CITY OF OREGON CITY HISTORIC REVIEW BOARD AGENDA

- a. HR-25-00014: New construction of a 6-unit multi-family building at the Sarah Hughes House (1102 7th St)

REQUEST: Request to add a new 6-unit multifamily structure on the same lot as the designated historic Sarah Hughes House

REVIEWER: Jude Thaddaeus | Planner

1 SITE PLAN
 0.1-SP 1" = 10'-0"

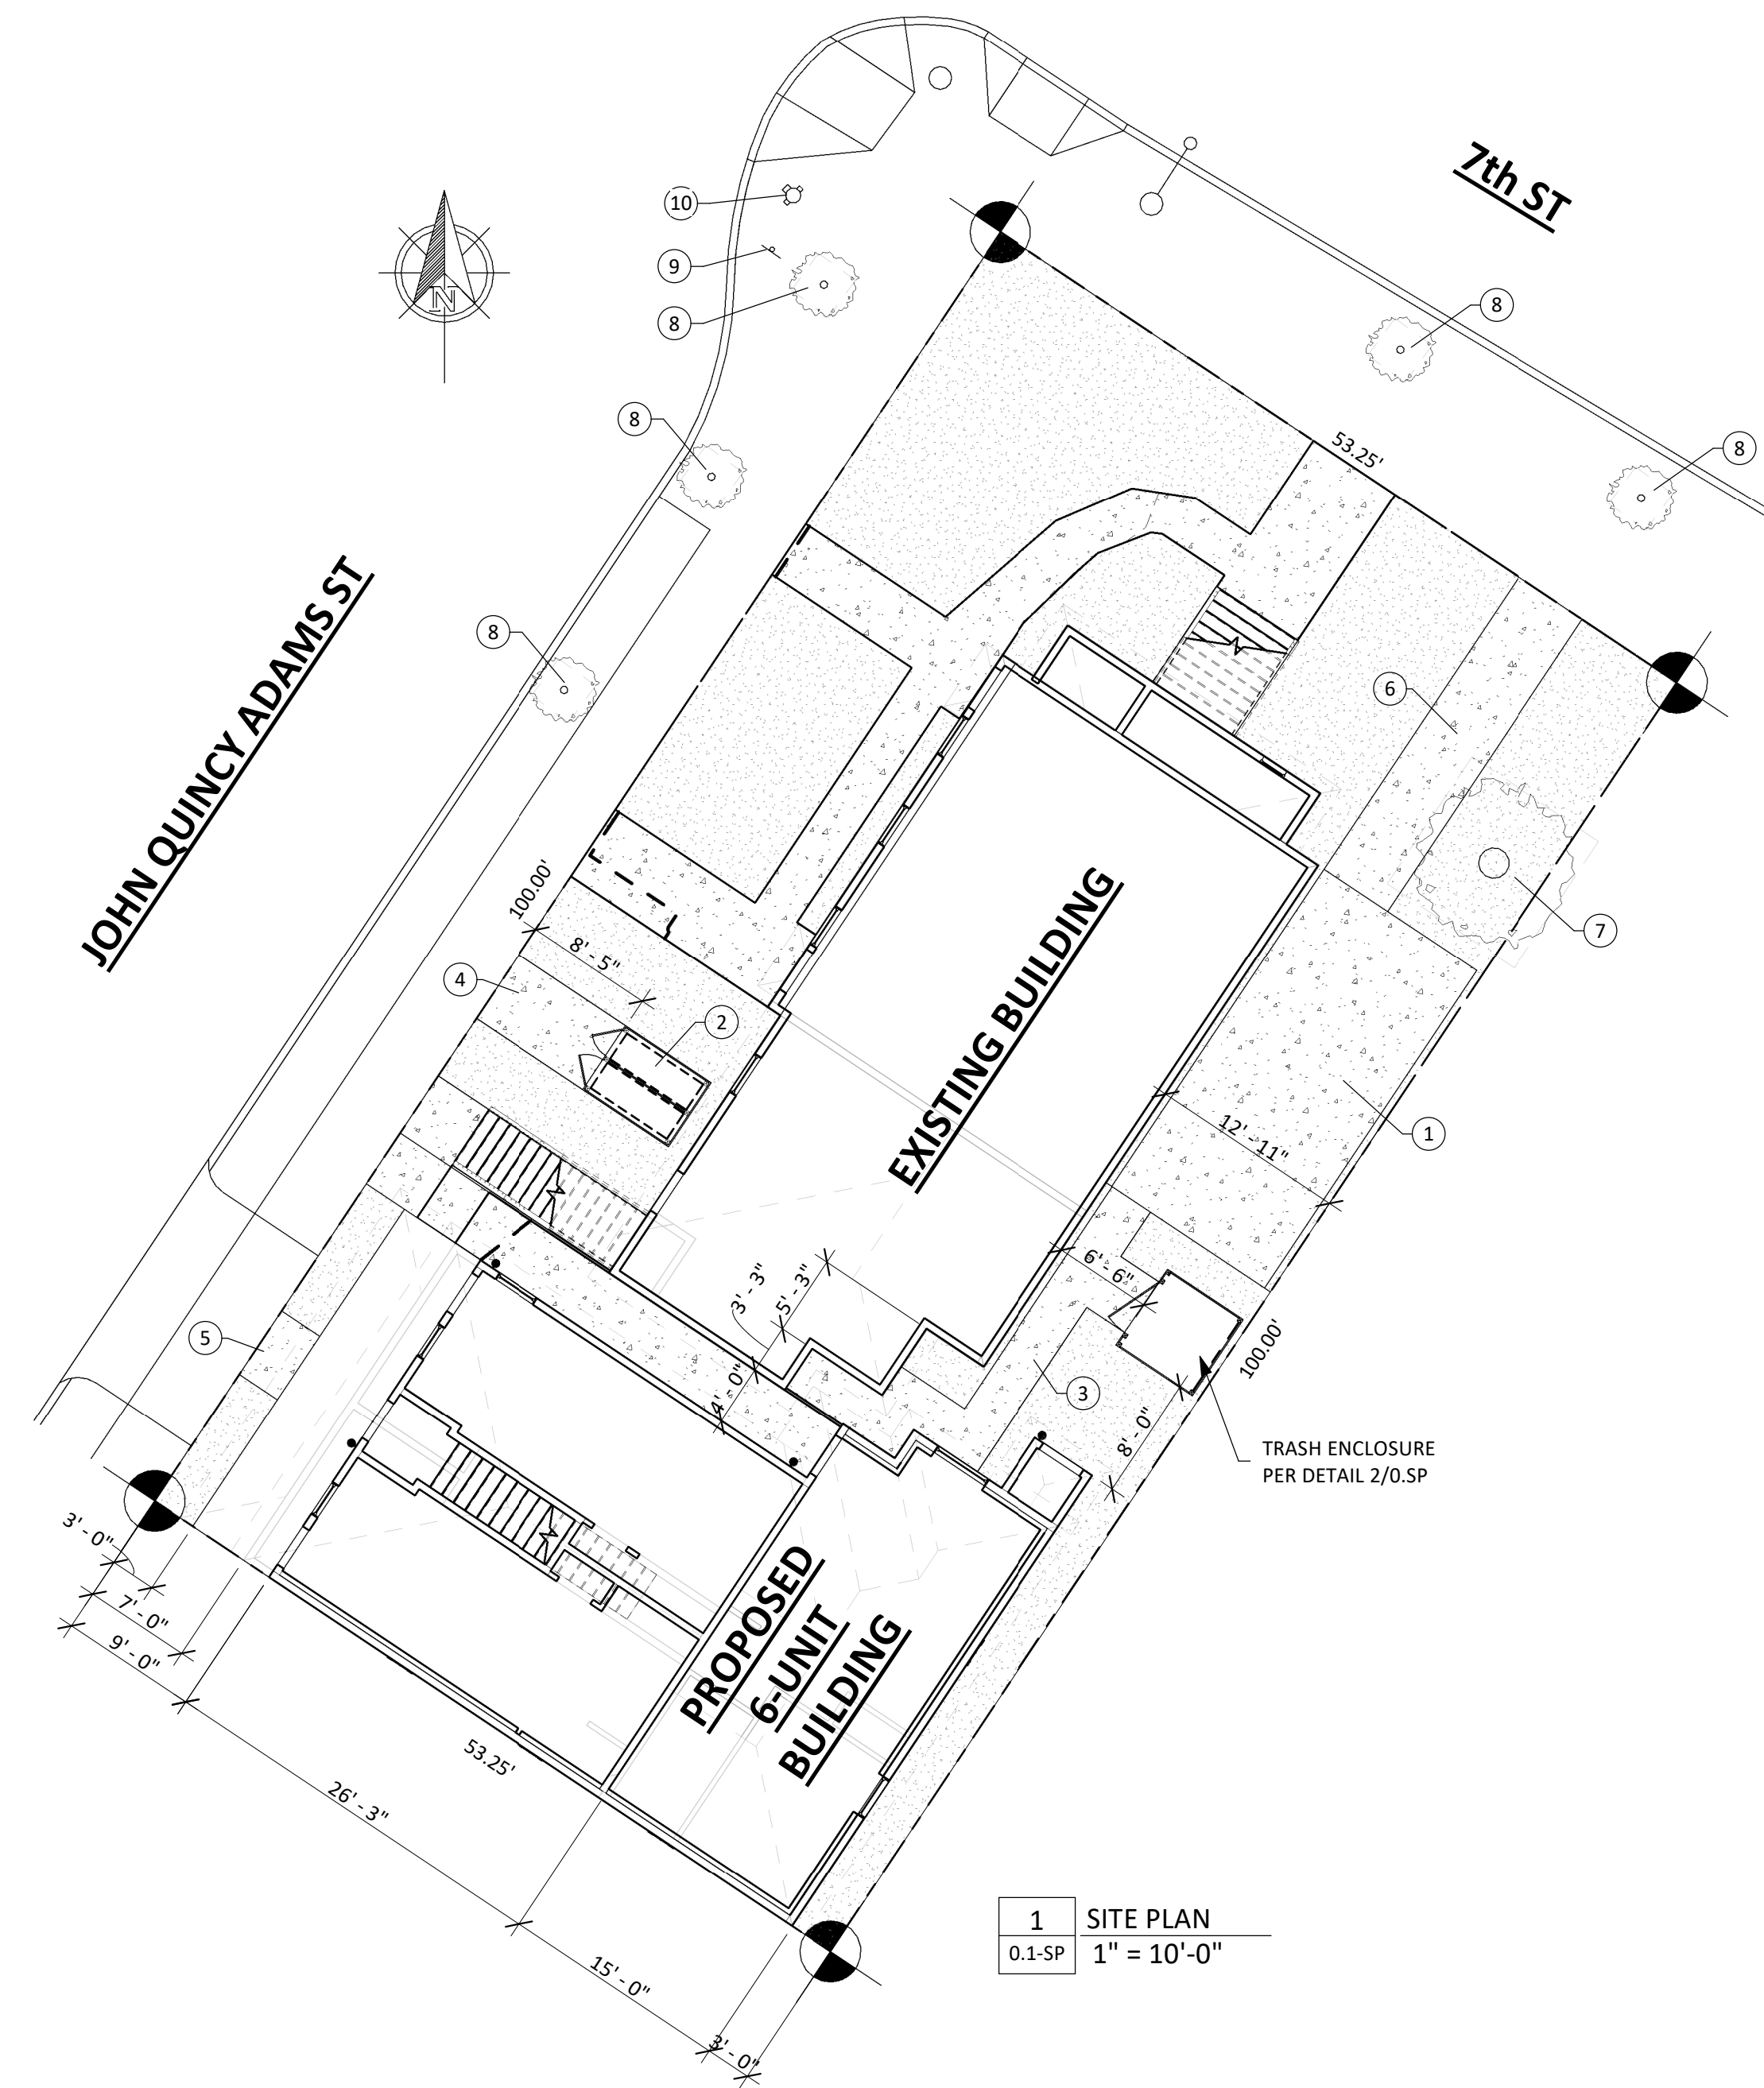
Comment: It is unclear what the setback to the proposed building is at the south property line. It will need a setback sufficient to insure that the retaining wall footing and the perforated drainage pipe shown on detail 4/4 as well as the roof gutter above are all within the property line.
